— ADD'L. SHOP WORK TO COLS. A50 & A51 —

REVISED			
DATE ____ BY ____	OPEN HOLES ____	ADD'L SHOP WORK FOR DWGS. 50 & 51	FRANKEL STEEL LIMITED
DATE ____ BY ____	PAINT ____	7 WORLD TRADE CENTER	220 ATTWELL DRIVE UNIT 1 REXDALE, ONTARIO M9W 5B2
DATE ____ BY ____	ERECTED BY ____	TISHMAN CONSTRUCTION — CUSTOMER	SQUAD FR
DATE ____ BY ____	FIELD PAINT ____	EMERY ROTH & SONS P.C. — ARCHITECT	MADE BY JM DATE Apr 30 CHKD. BY ✓ DATE
DATE ____ BY ____	INSPECTION ____	IRWIN G. CANTOR P.C. — ENGINEER	CONT. No. 84-15 SHEET 980

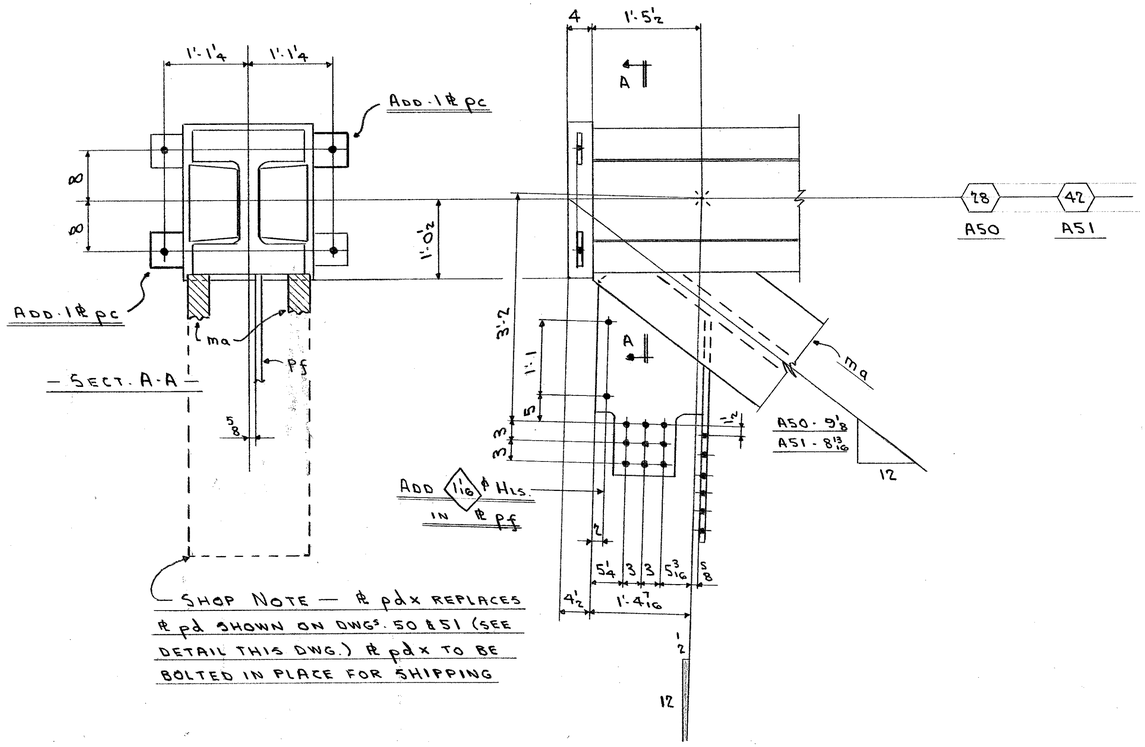
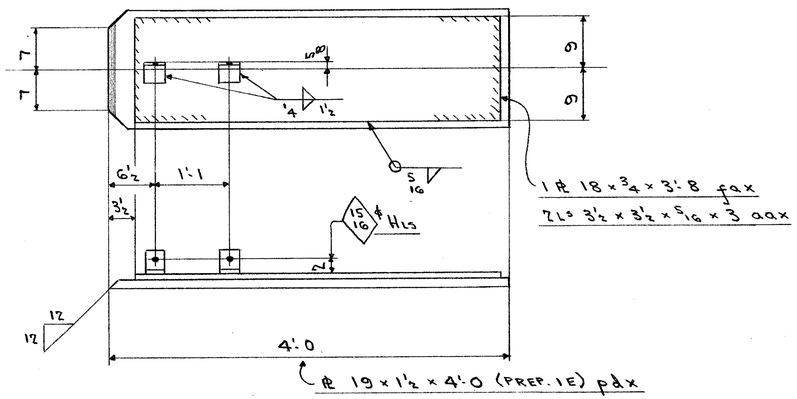
SHOP NOTE — # pdx REPLACES # pd SHOWN ON DWGS. 50 & 51 (SEE DETAIL THIS DWG.) # pdx TO BE BOLTED IN PLACE FOR SHIPPING
